Job Name: Land North of East Street Rusper West Sussex
Date: 11th November 2025
Prepared By: Matt Pendry BSc (Hons) MCIEEM (Principal Ecologist)
Subject: Technical Response – Planning ref: DC/25/0523

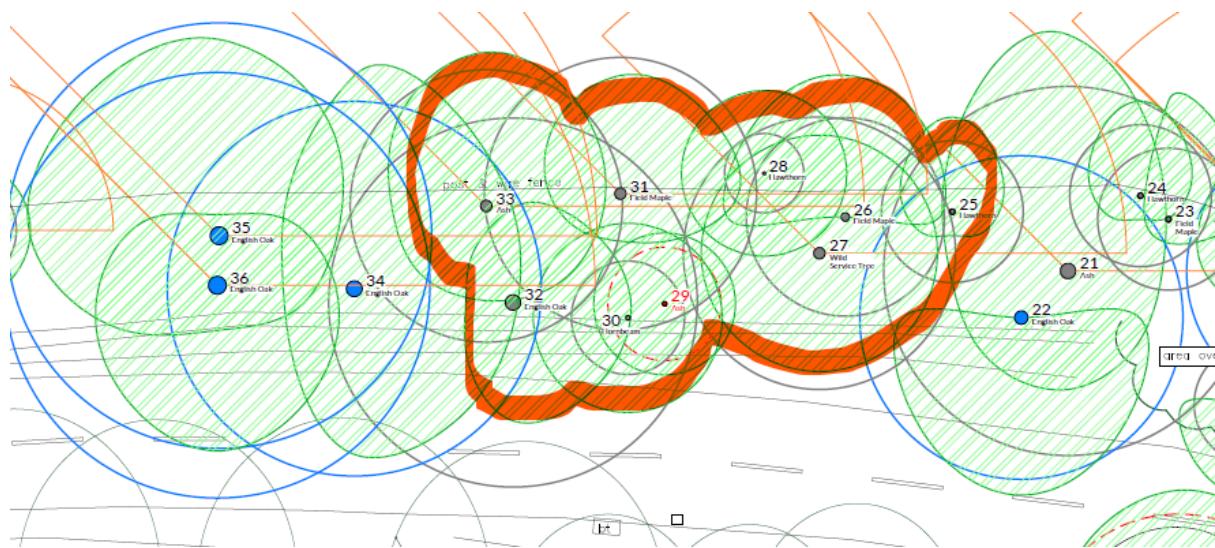
"The ecologist confirms that trees T25-T33 have been removed, with the loss of trees T31-T33 previously accounted for. As T26 and T27 are medium sized trees, these have been added separately to the baseline. The ecologist also states that T25 and T28 are hawthorns, which are considered a scrub species, and T29 and T30 are small, and therefore the loss of these trees does not require accounting for separately. Whilst this method is agreed, the tree schedule submitted to HDC does not contain any information on trees T26-T33 and appear to be omitted given the date of the Arboricultural Method Statement is November 2024 (prior to vegetation clearance works). As such, we request the tree schedule information for T26-T33. A total of 5x trees (4x medium and 1x large as per the metric entries) are accounted for in the ecologist's explanation, however at least 10x trees with an approximate DBH of medium or higher were identified during the site visit undertaken by me and the HDC Arboricultural Officer. Therefore, this tree schedule information is essential to ascertain the correct number.

The ecologist also confirms that all other Category U trees on site are to be retained. If any works are required to these trees in the future, crown reduction and monolithic works should be pursued over complete removal, with such details being incorporated into the HMMP. Please can this be added to the HMMP prior to signing of a legal agreement."

The trees which were cleared are highlighted in red below, which was cross-referenced with the tree schedule below. Trees are typically wider at ground level and taper to a thinner diameter at breast height. This may account for the discrepancy with the tree sizes recorded by the arboriculturist at breast height and the planning officer at ground level. It is possible many of the stumps may also relate the

scrub species such as hawthorn and blackthorn not recorded by the arboriculturist but instead forming part of the underlying scrub as opposed to individual trees.
